PRODUCT/PROCESS CHANGE NOTICE (PCN)

PCN #: L-0607-01	DATE: 4-Aug-2006	MEANS OF DISTINGUISHING CHANGED DEVICES:
Product Affected: Please see the attached list of the affected products shipped in tape and reel and in tubes		<input type="checkbox"/> Product Mark <input type="checkbox"/> Back Mark <input checked="" type="checkbox"/> Date Code <input type="checkbox"/> Other
Date Effective: 4-Aug-2006		Lot shipments will have Level 1 Moisture Sensitive Label, and with date code "0630".

PCN Type: Change in Moisture Sensitivity Level

From: MSL 3 Moisture Sensitive Label

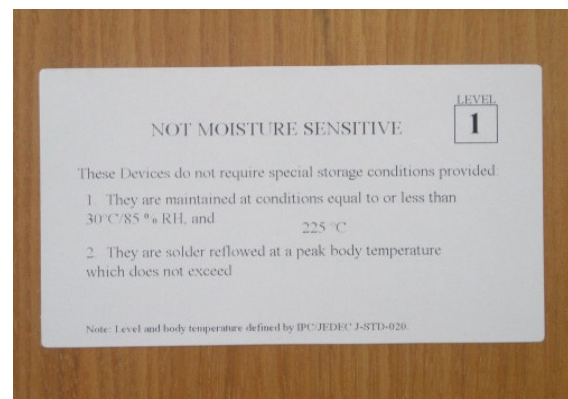
The affected products will be shipped without dry pack and labelled as MSL 1 according the JEDEC J-STD-033. There is no change to the assembly material set and the peak reflow temperature. Please refer below for the examples of moisture sensitive labels.
